SUBJECT: BROWNS FERRY NUCLEAR PLANT, UNIT 1 - ISSUANCE OF AMENDMENT  
UNDER EXIGENT CIRCUMSTANCES TO REMOVE NOTES FROM  
TECHNICAL SPECIFICATION FIGURES 3.4.9-1 AND 3.4.9-2  
(TAC NO. MF2564)

Amendment No. 284  
Renewed License No. DPR-33

SAFETY EVALUATION BY THE OFFICE OF NUCLEAR REACTOR REGULATION

**Figure 3.4.9-1  
Pressure/Temperature Limits for  
Mechanical Heatup, Cooldown following Shutdown, and  
Reactor Critical Operations**

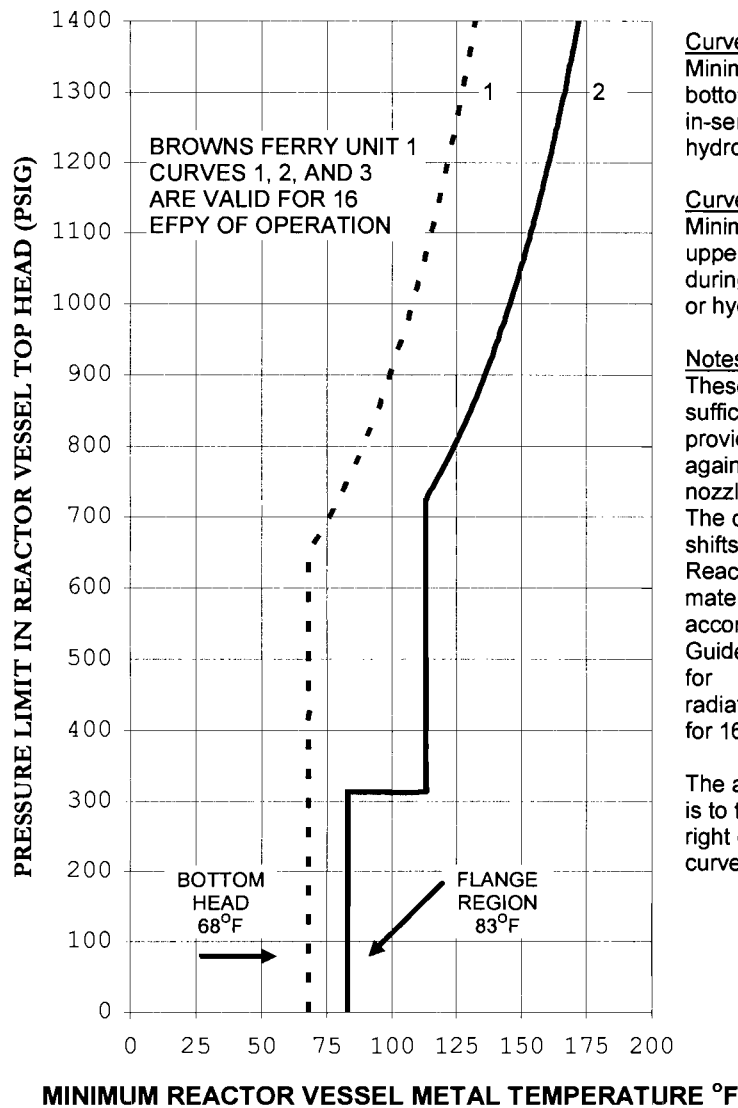
The amendment deletes the Notes that cover the Reactor Coolant System (RCS) Pressure and Temperature (P/T) Limit curves on TS 3.4.9, "RCS Pressure and Temperatures (P/T) Limits," Figures 3.4.9-1 and 3.4.9-2 are valid for 16 Effective Full-Power Years (EFPY) of operation. The current Notes state: "Do Not Use This Figure. This curve applies to operations > [greater than] 12 EFPY. For current operation, use previous curve, which is valid up to 12 EFPY." Therefore, to use the correct and previously approved P/T limit curves that are applicable up to 16 EFPY of operation, the Notes must be removed from TS Figures 3.4.9-1 and 3.4.9-2.

In addition, the amendment corrects the page header for these figures. The amendment changes current page header "Reactor Steam Dome Pressure," which is the title for TS 3.4.10, to "RCS P/T Limits."

Specifically, the licensee requested to delete the Notes that cover the RCS P/T Limit curves on TS 3.4.9, Figure 3.4.9-1, "Pressure/Temperature Limits for Mechanical Heatup, Cooldown following Shutdown, and Reactor Critical Operations," and Figure 3.4.9-2 "Pressure/Temperature Limits for Reactor In-Service Leak and Hydraulic Testing," that are applicable to 16 Effective Full Power Years (EFPY). The current Notes state: "Do Not Use This Figure. This curve applies to operations > [greater than] 12 EFPY. For current operation, use previous curve, which is valid up to 12 EFPY." Therefore, to utilize the correct and previously approved P/T limit curves once BFN Unit 1 operation has reached 12 EFPY, the Notes must be removed from TS Figures 3.4.9-1 and 3.4.9-2 that are applicable up to 16 EFPY.

In addition, the amendment corrects the page header for these figures. The amendment changes current page header, "Reactor Steam Dome Pressure," which is the title for TS 3.4.10, to "RCS P/T Limits."

Based on the foregoing, the NRC staff concludes that the licensee's proposed TS changes that delete a note that covers the BFN Unit 1 16 EFPY P/T limit curves on TS Figures 3.4.9-1 and 3.4.9-2 and changes to correct the TS page header for the figures from "Reactor Steam Dome Pressure" to "RCS P/T Limits" are acceptable, and that the revised P/T limit curves may be incorporated into the BFN Unit 1 TSs.

Notes

These curves include sufficient margin to provide protection against feedwater nozzle degradation. The curves allow for shifts in  $RT_{NDT}$  of the Reactor vessel beltline materials, in accordance with Reg. Guide 1.99 Rev. 2 to compensate for radiation embrittlement for 16 EFPY.

The acceptable area for operation is to the right of the applicable curves.
